NWB2NA0305

**9545-1-2-NAN-G**

**Re: Emergency Response/Spill Contingency Plan and Abandonment and Restoration Plan.**

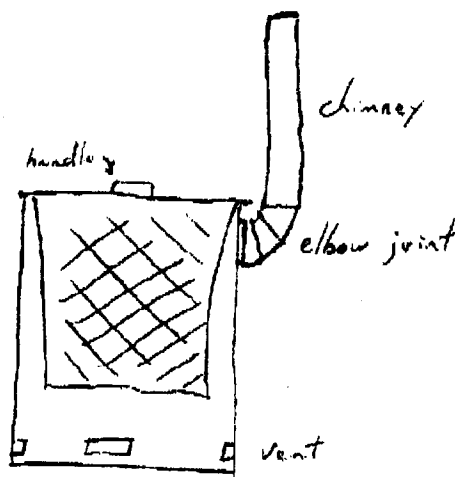
As per your request, here is an update on our incinerator plans: Due to a mis-communication between the welding company and myself, the exact plans you received from me were not constructed. It was reasonably close though. The most important part of the design is still that the lid and wire mesh basket are a one piece unit. This accommodates easy use and portability. The lid however was not constructed as a split-hinged lid. It is a whole lid but still has the 6" hole for the stove pipe on top. The lid opens from the basket at a hinge located behind the 6" hole at the lip of the basket. Remember the lip keeps the unit on top of the drum. The lid now has stoppers which can hold it open at a 90° angle to the basket.

I tested out the unit on ordinary household garbage. It contained thick cardboard, newspaper, plastic, leftover fish parts, an oyster tin, and two aluminum pop cans (among other things). With three holes punched in the bottom of a 45-gallon drum and only using regular unleaded gas & wood for fuel, the burn went very well. An excellent draft was created and smoke poured out the chimney (6' of stove pipe was used). Few ashes were left after the burn. Nothing was left of the aluminum pop cans but the oyster tin and some tin-foil were left unscathed. I was quite pleased with the results however we still recommend a slower burning fuel for incineration.

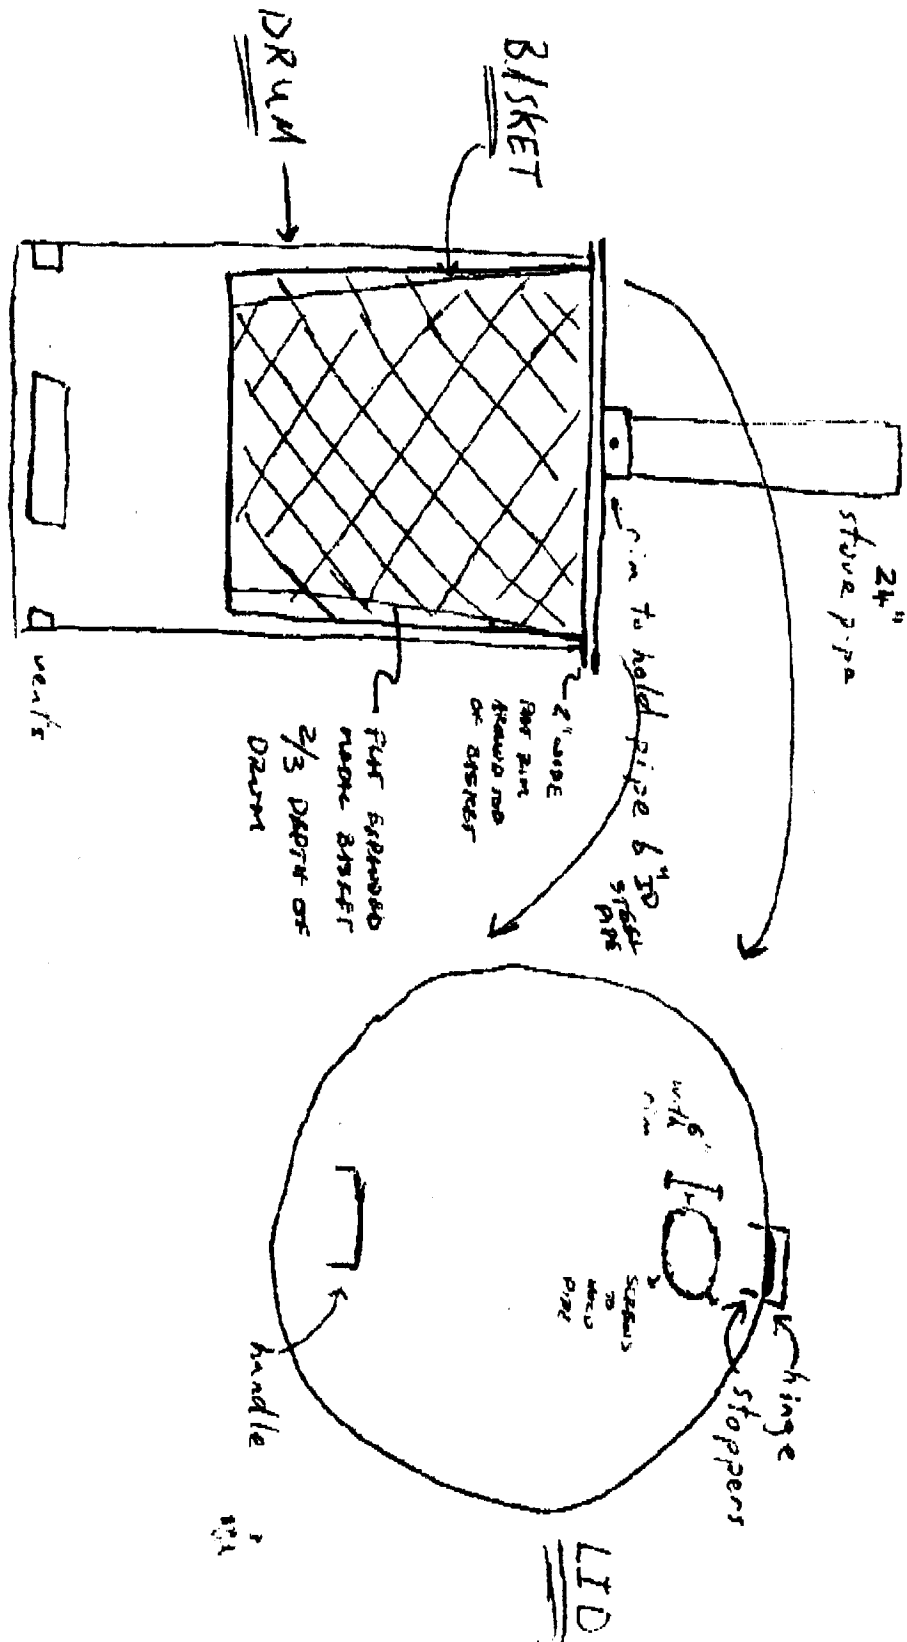
There is a problem for our model however. The lid acts as a flue channelling the flow of smoke and heat to the chimney. If the lid is opened during incineration, it is likely that flames may shoot out at the body opening it. The operator will not be able to add garbage to the unit unless the burn is completed. This may pose a problem to the larger camps which create lots of garbage to burn at once. However if multiple incinerator units are in place at a camp, and burns are completed after every meal, the units should be able to withstand the garbage load created.

Andy [REDACTED] (Con. Ed. Officer, Yellowknife) likes the idea of moving the chimney to the side of the drum. Using an elbow joint affixed to the side, the stove pipe would protrude from there. The lid and basket would still be a one piece unit. Andy is now working on getting that model made up and sent out. This model would be safer as the flue is on the side of the barrel, not the top. However, the problem with this is that assembly is required for use. In the field, someone will have to punch a hole in the side of the drum and then bolt the elbow joint to it. I believe the best model should require little or no assembly or maintenance.
